Product Change Notification

Product affected: MTA 206 PA, MTA 206 PA-B, MTA 206 PA-G, MTA 206 PA-PC

Effective date: from production date July/August 2008

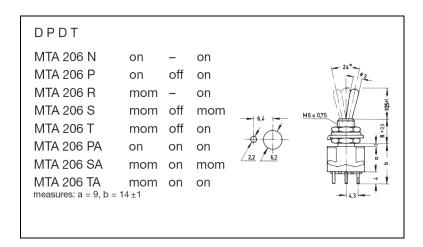
Due to improved switching mechanism, the dimensions of "PA" switches was harmonised with other switching functions (like N, P, R, S, T).

Old style

DPDT					
MTA 206 N	on	-	on		2/0
MTA 206 P	on	off	on		7/3
MTA 206 R	mom	_	on		
MTA 206 S	mom	off	mom		M6 x 0,75
MTA 206 T	mom	off	on	1	
measures: a = 9, b = 14±1				2,2 6,2	
MTA 206 PA	on	on	on		THE PLANT OF THE PARTY OF THE P
MTA 206 SA	mom	on	mom		4.3
MTA 206 TA	mom	on	on		7-
measures: $a = 11,5$, $b = 16,5 \pm 1$

New style
